Draft revision of global technical regulation on Evaporative emission test procedure for the Worldwide harmonized Light vehicle Test Procedure (WLTP EVAP)

II. Text of the global technical regulation

Annex 1

Figure A1/21
Canister bench ageing procedure

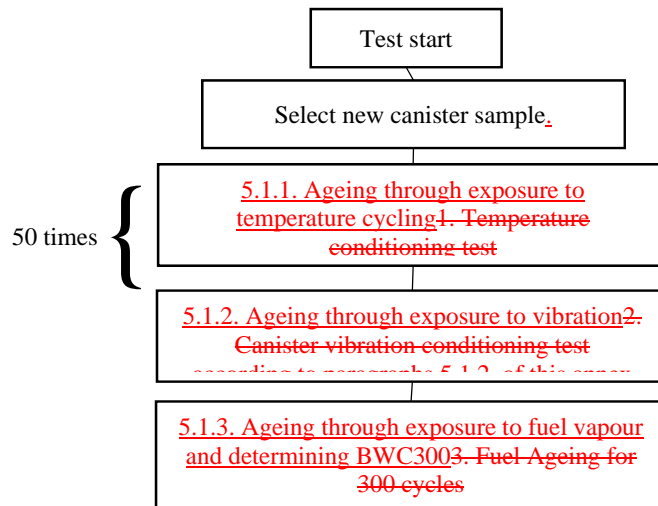
Before performing the hot soak and diurnal losses sequences, the canister shall be aged according to the procedure described in Figure A1/21.

Figure A1/32
Temperature conditioning cycle

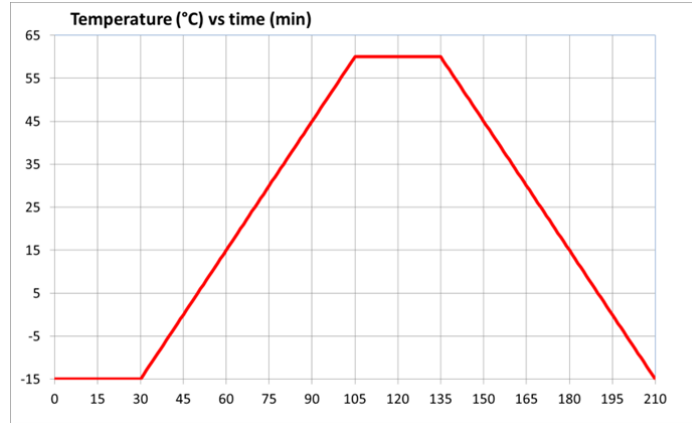
The canister shall be cycled between temperatures from -15 °C to 60 °C in a dedicated temperature enclosure with 30 minutes of stabilisation at -15 °C and 60 °C. Each cycle shall last 210 minutes (see Figure A1/32).

The temperature gradient shall be as close as possible to 1 °C/min. No forced air flow should pass through the canister.

The cycle shall be repeated 50 times consecutively. In total, this procedure lasts 175 hours.

Figure A1/43
Determination of the PF

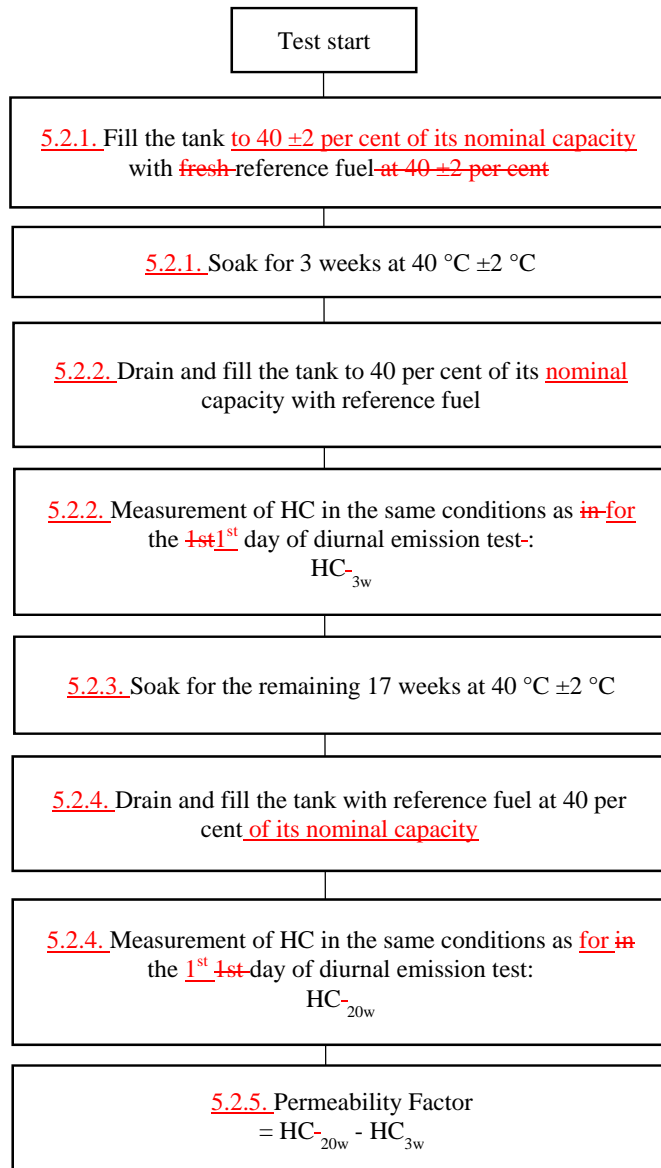
- (b) Loading rate;
 - (c) Fuel specifications;
 - ~~(d) BWC measurements.~~
- 5.2. Determination of the ~~Permeability Factor (PF)~~ of the fuel tank system (~~see Figure A1/43~~)

- 5.2.1. The fuel tank system representative of a family shall be selected and mounted on a rig in a similar orientation as in the vehicle. The tank shall be filled to 40 ±2 per cent of its nominal capacity with ~~fresh~~ reference fuel at a temperature of 18 °C ±2 °C. ~~The tank shall be filled to 40 ±2 per cent of the nominal tank capacity.~~ The rig with the fuel tank system shall be placed in a room with a controlled temperature of 40 °C ±2 °C for 3 weeks.
- 5.2.2. At the end of the third week, the tank shall be drained and refilled with ~~fresh~~ reference fuel at a temperature of 18 °C ±2 °C to 40 ±2 per cent of its the nominal tank capacity.
- Within 6 to 36 hours, the rig with the fuel tank system shall be placed in an enclosure. The last 6 hours of this period shall be at an ambient temperature

Figure A1/4

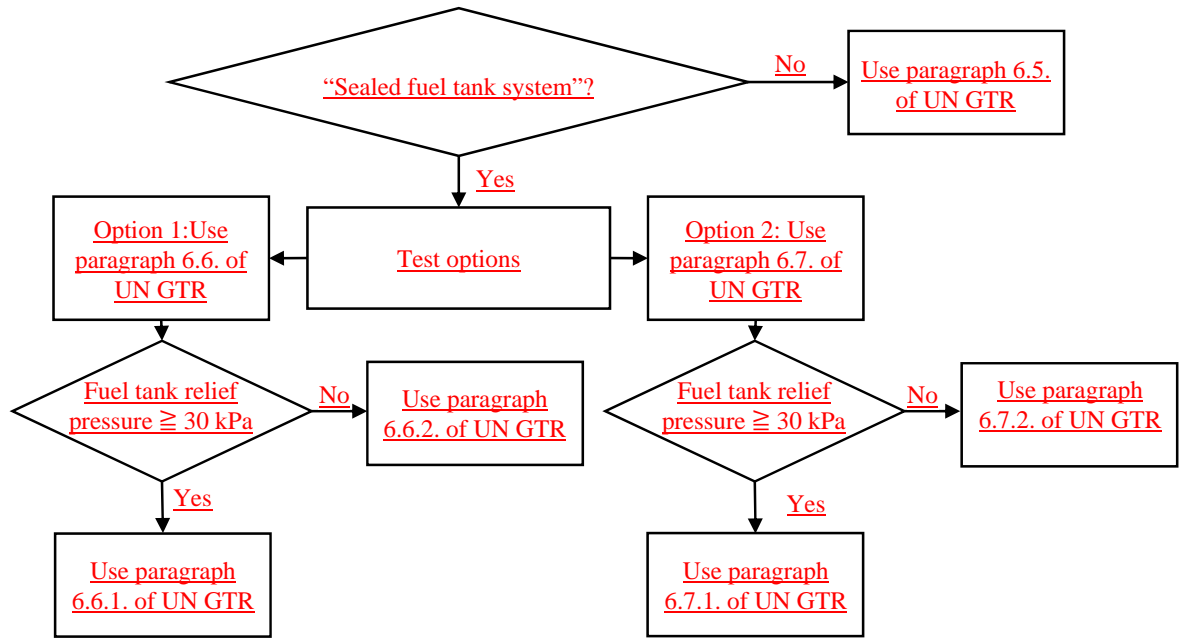
6.4.1. The test procedure for non-sealed and sealed tank systems shall be selected according to the flow chart described in Figure A1/4.

Figure A1/5a

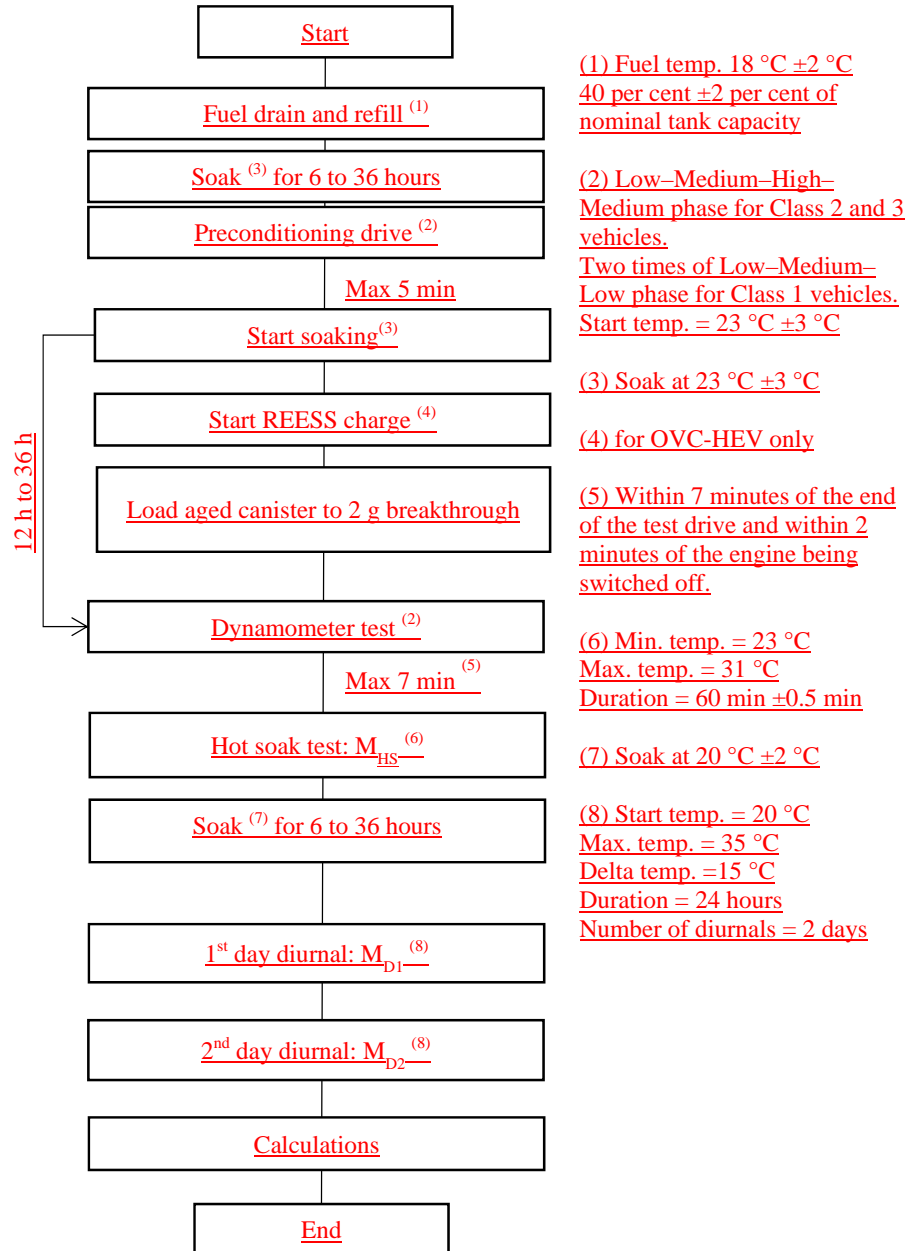
Test procedure for non-sealed fuel tank systems5.3.26.5.1.
